Subject: **Response to NRC Request for Additional Information Regarding
Proposed Technical Specification Change to Revise the Leakage Rate
Through MSIVs -TS-485 (TAC NOS. MF3124, MF3125, MF3126, MF8124,
MF8125, and MF8126)**

**TENNESSEE VALLEY AUTHORITY
BROWNS FERRY NUCLEAR PLANT UNITS 1, 2, AND 3
PROPOSED TECHNICAL SPECIFICATION CHANGE TO REVISE
THE LEAKAGE RATE THROUGH MSIVS – TS-485
DOCKET NOS. 50-259, 50-260, AND 50-296
(TAC NOS. MF3124, MF3125, and MF3126).**

**RESPONSE TO NRC REQUEST FOR ADDITIONAL INFORMATION (RAI)
Balance-of-Plant Branch (SBPB)**

**RESPONSE TO NRC REQUEST FOR ADDITIONAL INFORMATION (RAI)
Containment and Ventilation Review Branch (SCVB)**

Figure 1

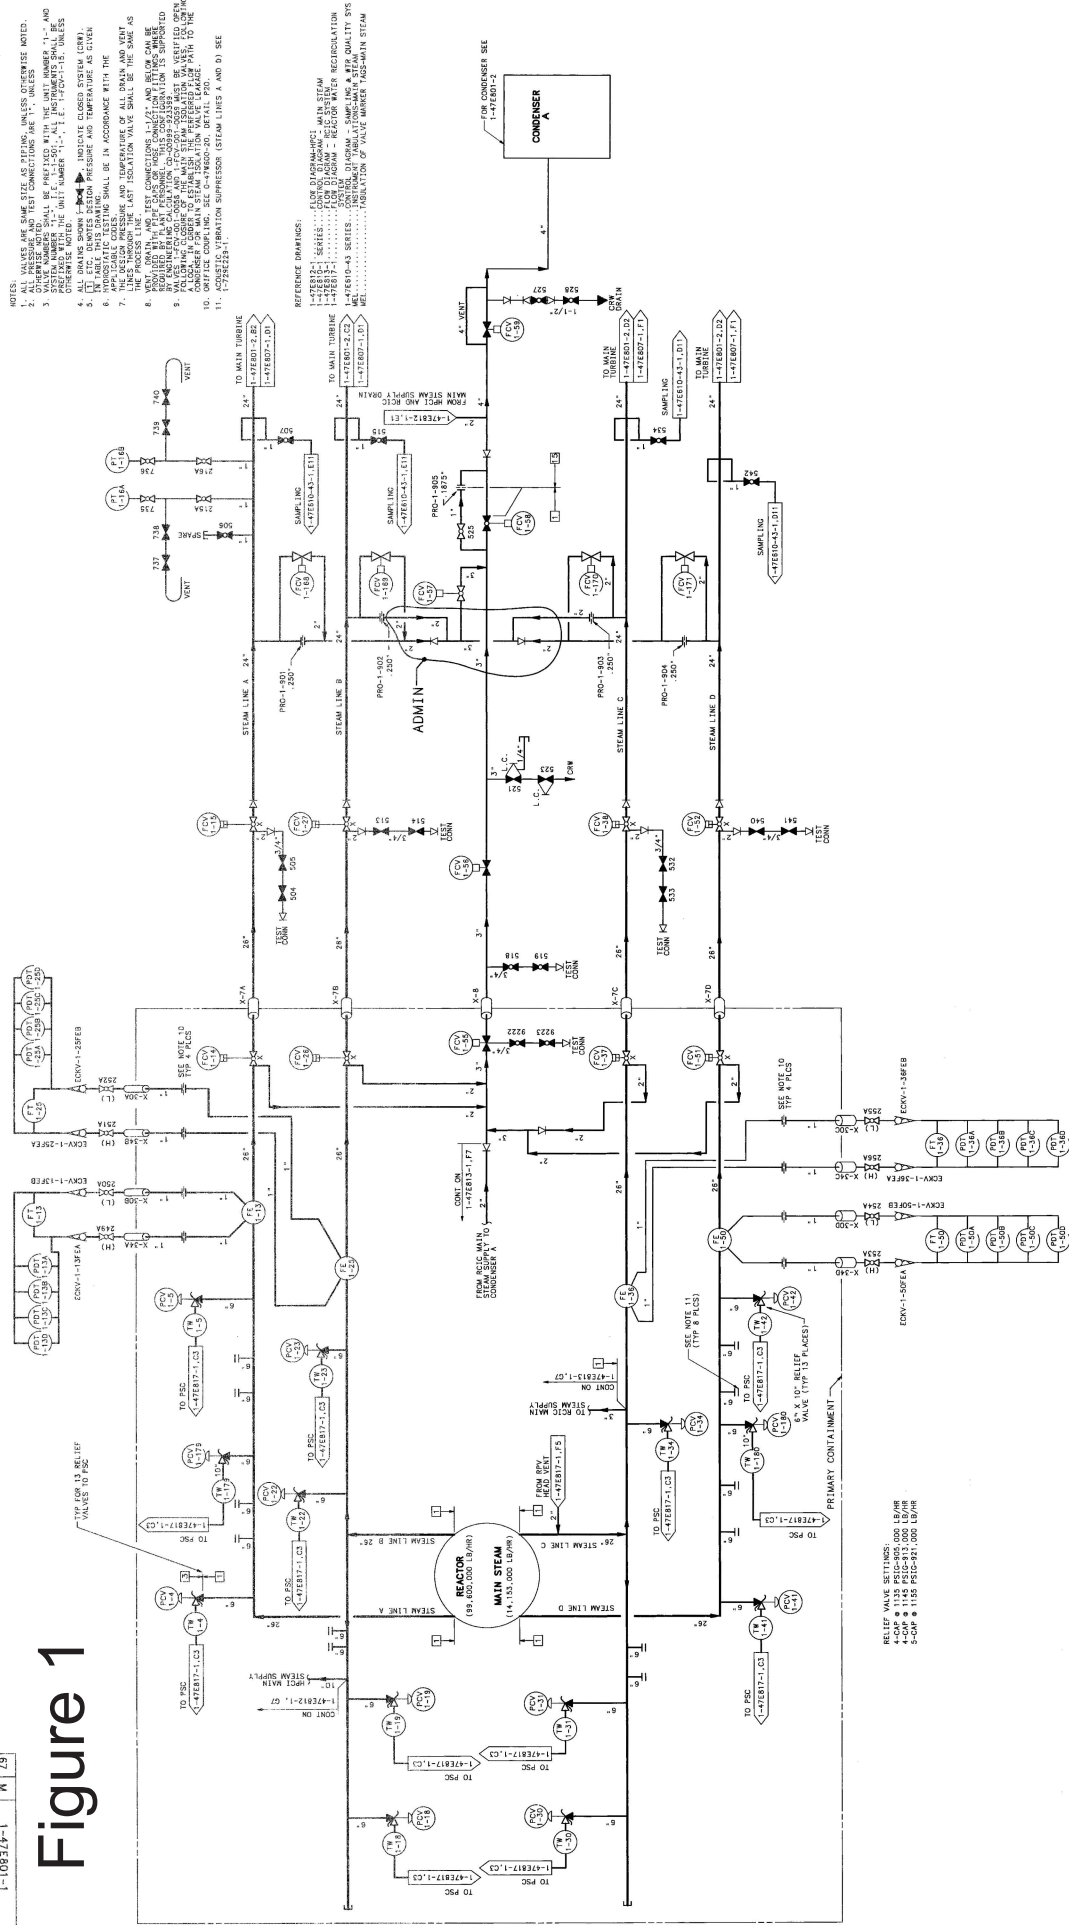
Descriptions of drain pathways appear to be different between the FSAR reference and the statement in the LAR. Additionally, the licensee implies that some operator actions may be necessary for secondary drain flow path alignment.

- a. Clarify any differences in how the primary and secondary ALT pathway is operated post-accident versus the mainstream line drains systems while at power, startup, or shutdown. Consider revising the UFSAR by adding the two ALT pathway descriptions to the UFSAR.*
- b. Explain how main control room (MCR) operators know when or how the primary flow path, which is passive, is unavailable in order to line-up the secondary path. Provide drawings and/or describe the instruments that are available to the MCR staff in order to make such an assessment.*

The inside drain line described in the above FSAR passage is the drain line from the Inboard Main Steam Isolation Valves (MSIVs). This inside drain line is not part of the ALT pathway (see Figure 1). The drain line inside of the drywell connects to a three-inch header which exits primary containment. This header has a valve inside of containment (FCV-1-55) and a valve outside of containment (FCV-1-56), both of which are normally closed. The header then continues on through valves FCV-1-58 and FCV-1-59 to the condenser.

- a) Referring to Figure 1, the proposed primary ALT flow pathway for the main steam line drains, while at power, taps off the Steam Lines A through D and flows through the four 0.25-inch orifices. Steam continues to flow through a three-inch header, then through the open (motive power will be removed) main steam drain to condenser isolation valve (FCV-1-57). The steam flow continues through a 0.1875-inch orifice around valve FCV-1-58 and lastly, through the four-inch vent bypass line (around valve FCV-1-59) into the condenser.

The proposed secondary ALT flow pathway for the main steam line drains at power is through the four open isolation valves (FCV-1-168, FCV-1-169, FCV-1-170, and FCV-1-171) off the Steam Lines A, B, C, and D. Steam continues to flow through the open (motive power removed) main steam drain to condenser isolation valve (FCV-1-57). The steam flow continues through main steam drain to condenser isolation valve (FCV-1-58) and through main steam drain to condenser isolation valve (FCV-1-59) into the condenser.

The difference between the proposed secondary ALT pathway post-accident and the proposed secondary ALT pathway at power is that at power, the four open isolation valves (FCV-1-168, FCV-1-169, FCV-1-170, and FCV-1-171) off the Steam Lines A, B, C, and D will automatically close if power is available, when any MSIV is closed and the turbine speed is greater than 1700 rpm, or will, on a loss of power (post accident), remain in the position they were in prior to power being lost. Consequently, the 0.25-inch orifices in the bypass lines around FCV-1-168, FCV-1-169, FCV-1-170, and FCV-1-171 will be the credited pathway. Additionally, the main steam drain to condenser isolation valves FCV-1-58 and FCV-1-59 will fail on loss of power to the position they were in prior to power being lost. Because these valves are normally closed, the failed position will be closed. With these valves closed, the 0.1875-inch orifice around FCV-1-58 and the vent line around FCV-1-59 becomes the credited pathway.

Figure 3

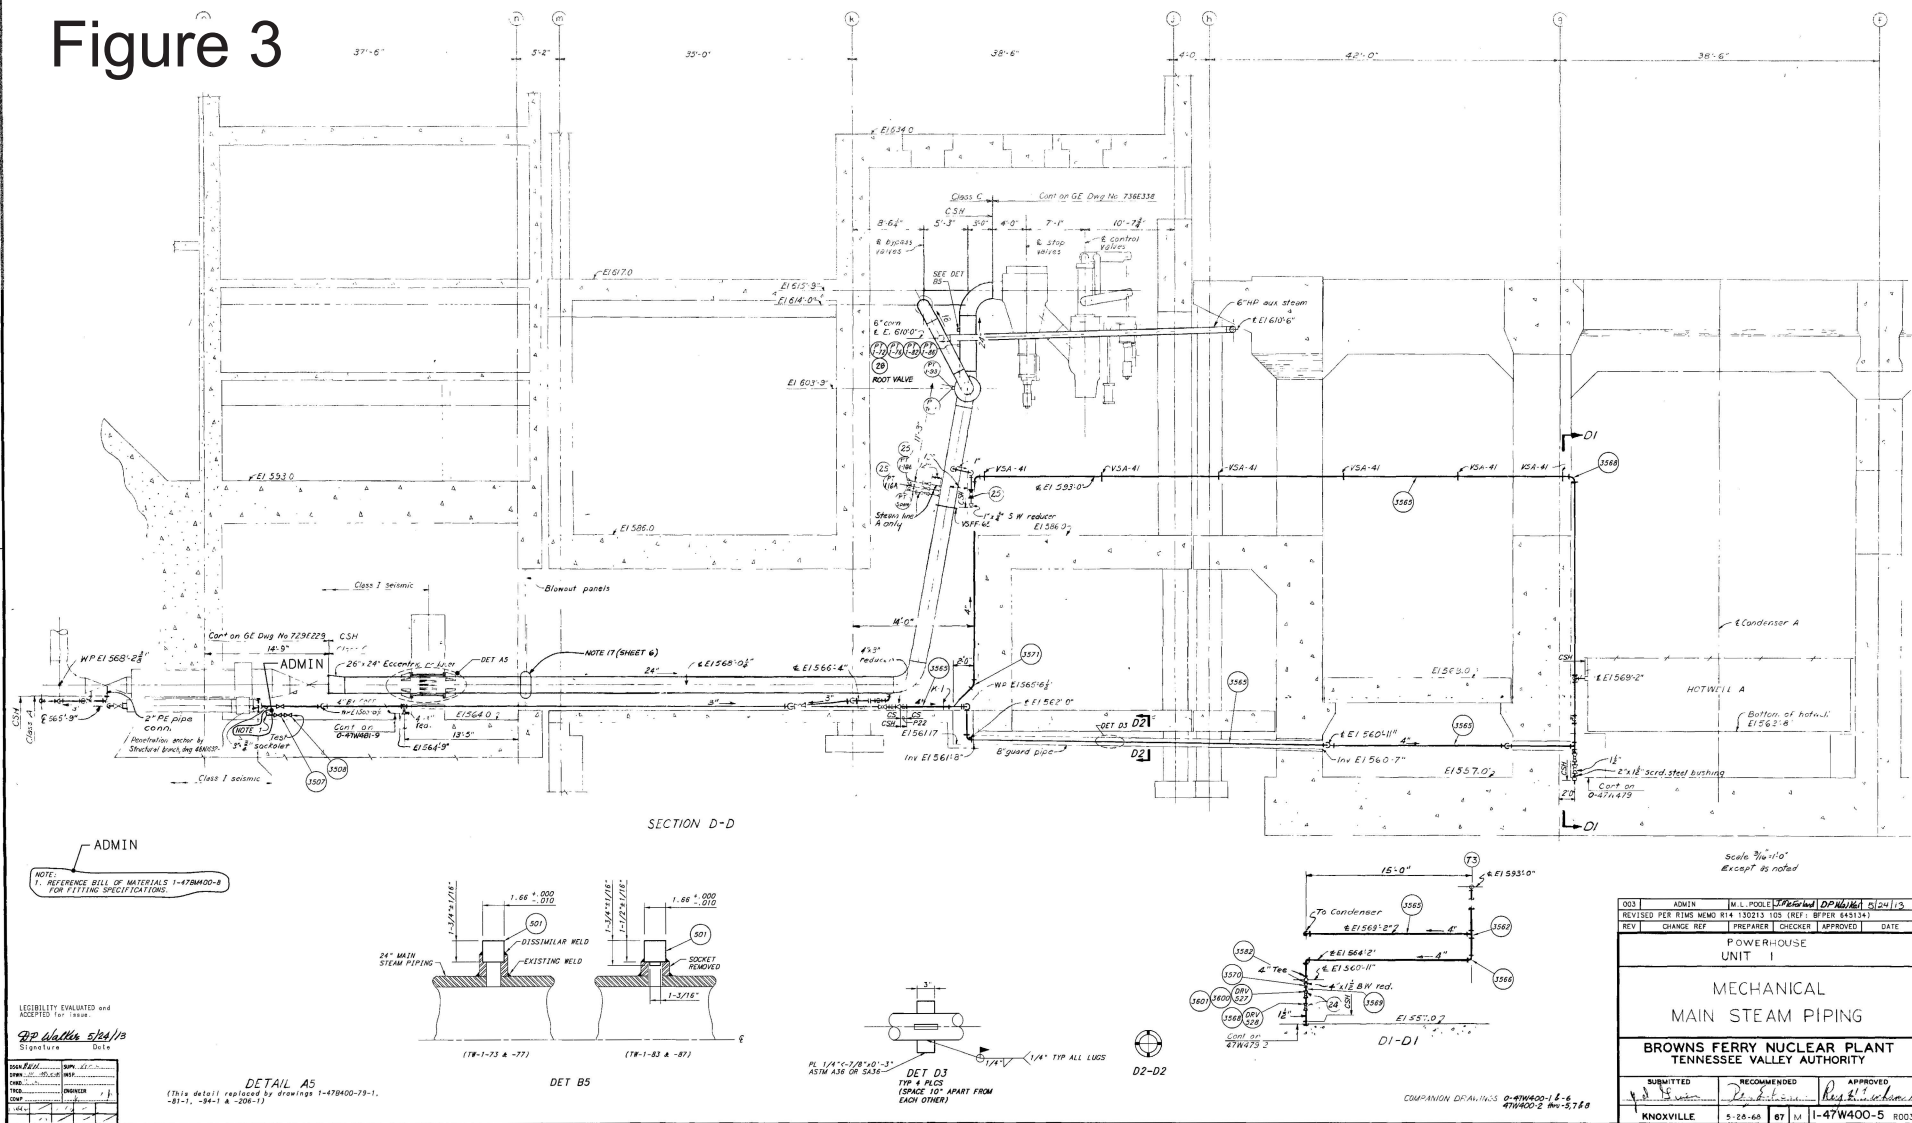
Descriptions of drain pathways appear to be different between the UFSAR reference and the licensee statements in the LAR.

Confirm that there are no restrictions in the bypass line around FCV-1-59 and provide explanation of the system configuration and why the valve is closed and why the valve is necessary. If FCV-1-59 is truly a full bypass, describe why FCV-1-59 exists and why it needed to be open in the secondary ALT pathway.

As shown in Figures 2 and 3, FCV-1-59 is the final valve in the proposed secondary ALT pathway to the condenser hotwell. This section of piping contains a vent line around the valve to permit continuous draining of the steam line low points. This four-inch diameter vent line has no restrictions to allow continuous draining of the steam line low points.

Valve FCV-1-59 is cycled during pre-startup/standby readiness requirements, startup, and cooldowns to drain condensate back into the condenser. It can also be used during refueling operations to facilitate drain down after flooding MSIVs for Local Leak Rate Tested (LLRT) and keeping MSIV lines drained downstream of the Inboard MSIVs. After the main steam line drain systems are drained of any condensate and the drain lines are warmed, FCV-1-59 is closed for power operation. When a drywell radiation alarm is received, operators are procedurally directed to open the lower main steam line drain valve to the condenser (FCV-1-59), which is the proposed secondary ALT pathway.
